1984 - 1987 Corvette: Service Bulletin: Front Center Air Deflector Damage

Bulletin Number: 87-263-10, Section 10

Date: Jan., 1988

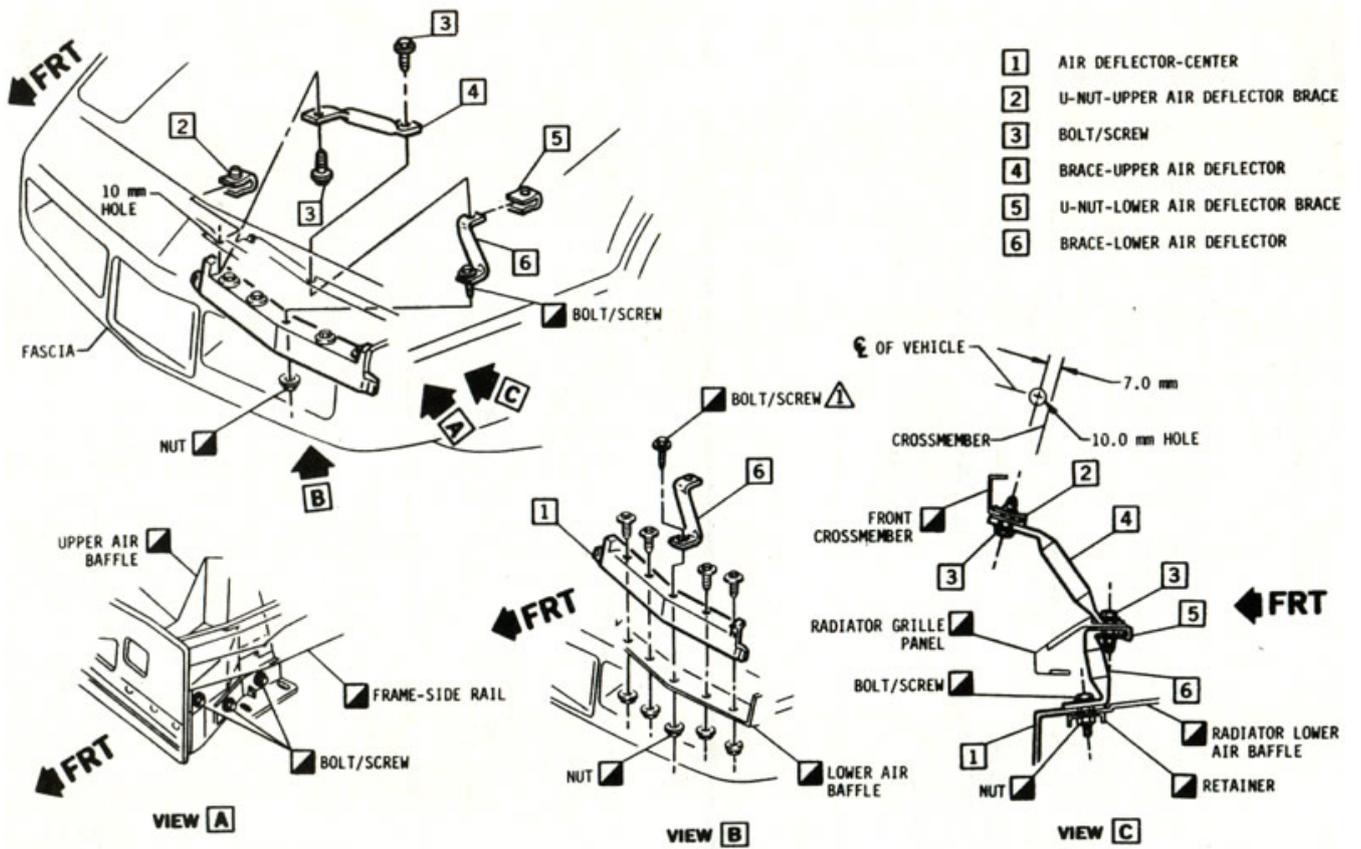
Comments that the front air deflector (dam) gets damaged by bumps, curbs and snow piles may be received. A service kit with two new braces has been released to address this situation on affected vehicles.

This condition can be addressed by installing the braces per the illustration and instructions provided in the service kit. The part numbers for the service kits are as follows:
